PAPERMILL POND DAM

CT. 00471

Review of Non-Federal Dam Inspection Draft Report

NATIONAL PROGRAM OF INSPECTION OF NON-FEDERAL DAMS  
DRAFT REPORT REVIEW COMMENTS  
PAPERMILL POND DAM, IDENTITY NO. CT 00471  
WATER CONTROL BRANCH

D-13

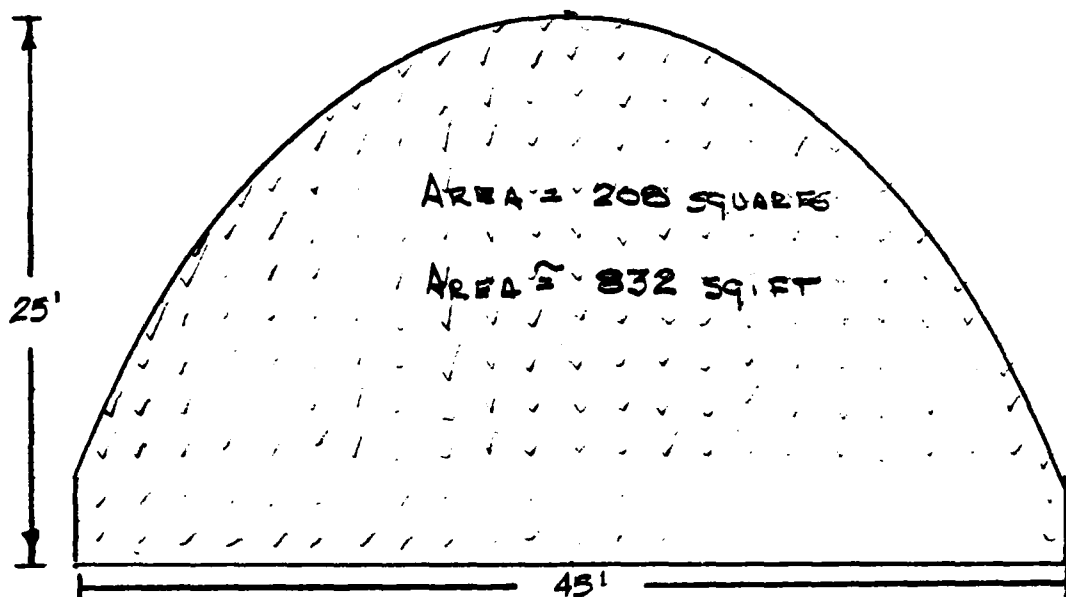
D-13

✓ Can you put a grid on this plate?
